MCF5373 Chip Errata

Silicon Revision: All

This document identifies implementation differences between the MCF537x processors and the description contained in the *MCF5373ColdFire® Reference Manual*. Refer to <http://www.freescale.com/coldfire> for the latest updates.

Figure 5. Qualifying multiple chip selects using a buffer

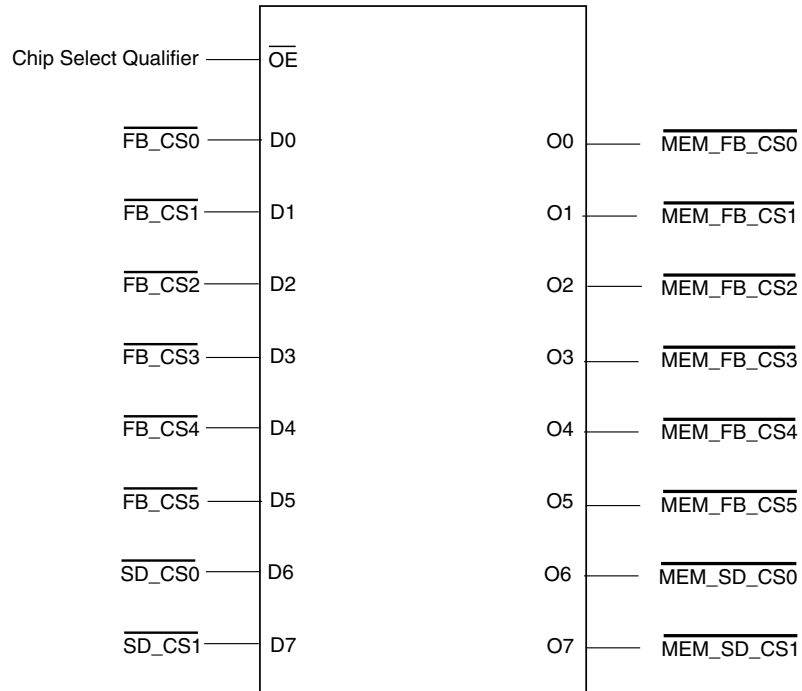
The second step of the workaround is to use the qualifier signal generated to qualify or mask chip select signals to external devices as needed.

In the diagram above “MEM_” is used to differentiate the chip select signals from the processor and the qualified versions that would be connected to external memories. Each of the “MEM_” signals should include a pullup resistor to force the signal high while the buffer is disabled.

This issue has been fixed starting with the 6M29B mask set. The fix that has been implemented ensures that $\overline{SD_CS}[1:0]$ and $\overline{FB_CS}[2:0]$ will either drive high or float during reset. These pins will never driver low during the reset sequence. The operation of $\overline{FB_CS}[5:3]$ is unchanged. The state of $\overline{FB_CS}[5:3]$ can still be undefined during the reset sequence.
